CHANGE NOTIFICATION

PCN#033015

Subject: Notification of Change to LTC6246, LTC6252, LTC6255 Die

LTC6246 X-wire layout (Before)

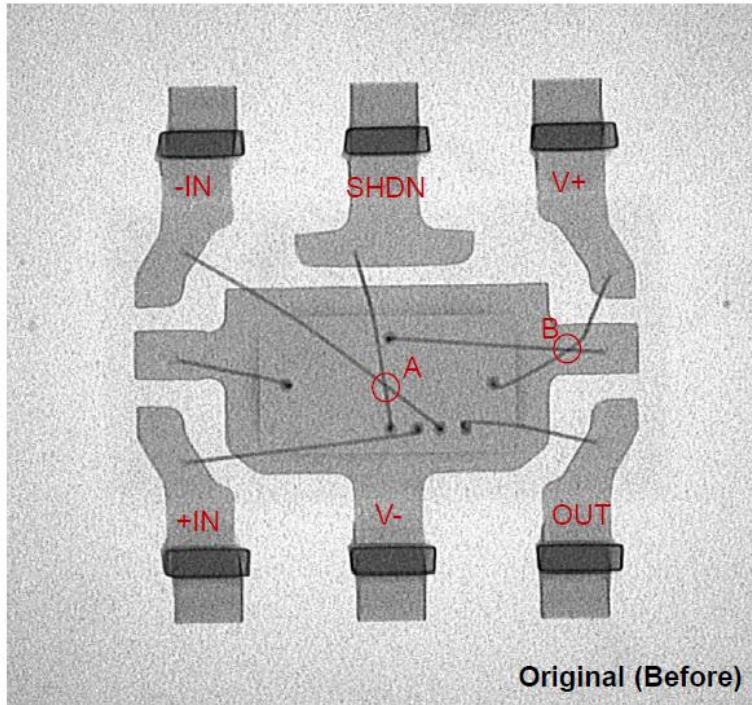
Insulated X-wire allowed wires to cross at points **A** and **B**.

In the original design, the logic signal routed to pad X is connected to V- via a bond wire to the lead frame.

In the original design, the SHDN signal is routed to bond pad Y.

On-chip metal routing edits make it possible to change the bond pad X and Y assignments. This will eliminate the need for insulated bond wires.

LTC6246 layout (After)

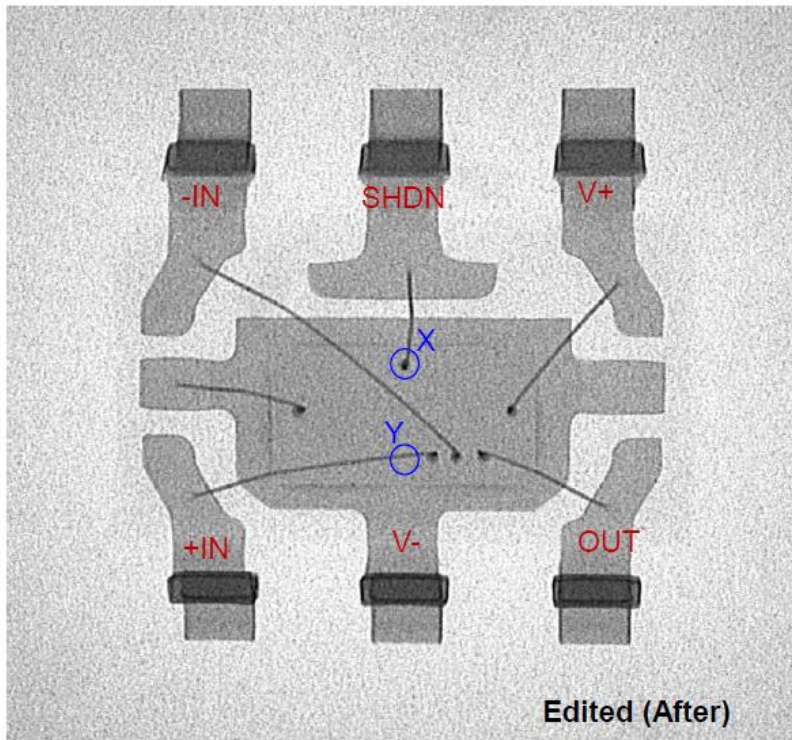
In the edited design, the logic signal previously routed to pad X is connected on-chip to V-. This eliminates the need for a bond wire from pad X to the paddle, allowing pad X to be wired differently, and reducing the bond wire count from 7 to 6 bond wires.

The SHDN signal is re-routed on-chip from bond pad Y to bond pad X. Pad X is wire bonded to SHDN pin rather than to the paddle.

Wire bond to pad Y is eliminated. Bond wires no longer cross, and the need for insulated bond wires is eliminated.

LTC6246 Before and After Summary

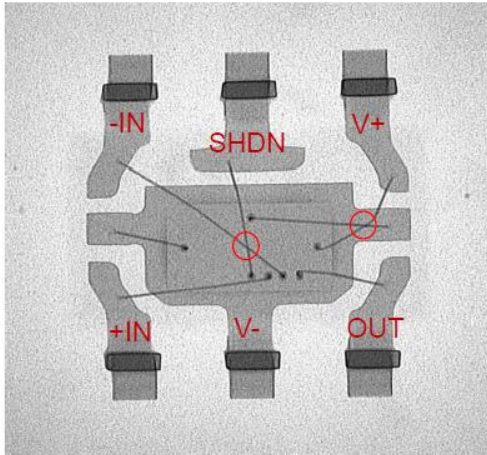
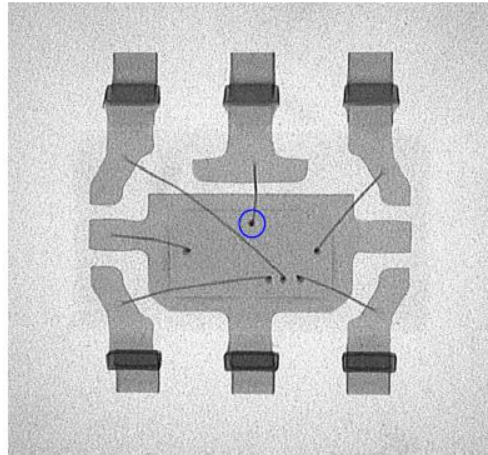
X-wire layout (Before)

Standard-wire layout (After)

LTC6252 Before and After Summary

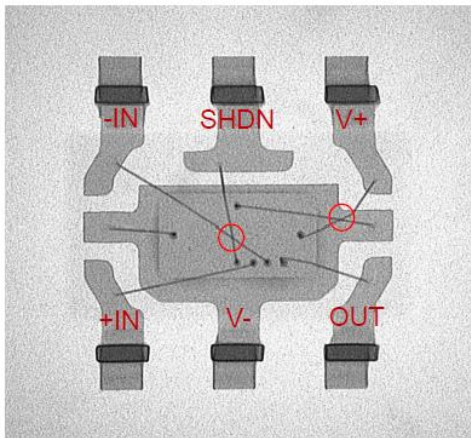
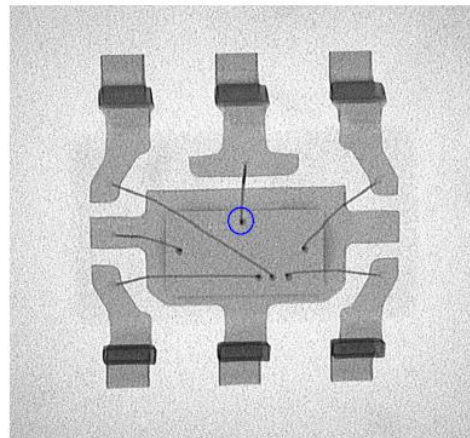
Standard-wire layout (After)

See LTC6246 for full explanation of changes.

LTC6255 Before and After Summary

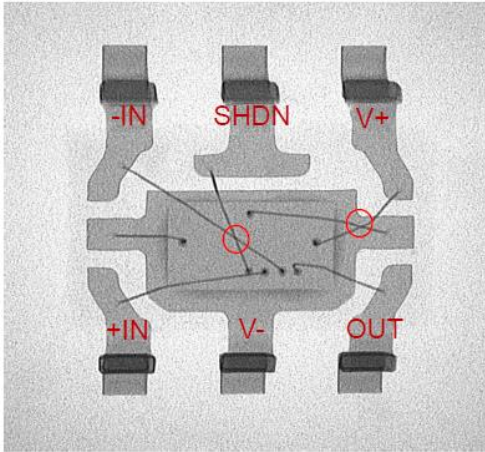
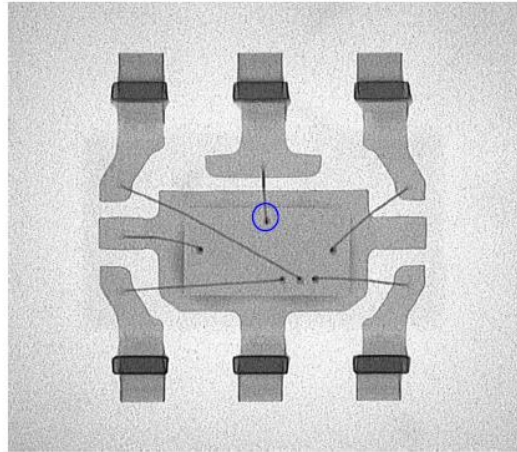
Standard-wire layout (After)

See LTC6246 for full explanation of changes.
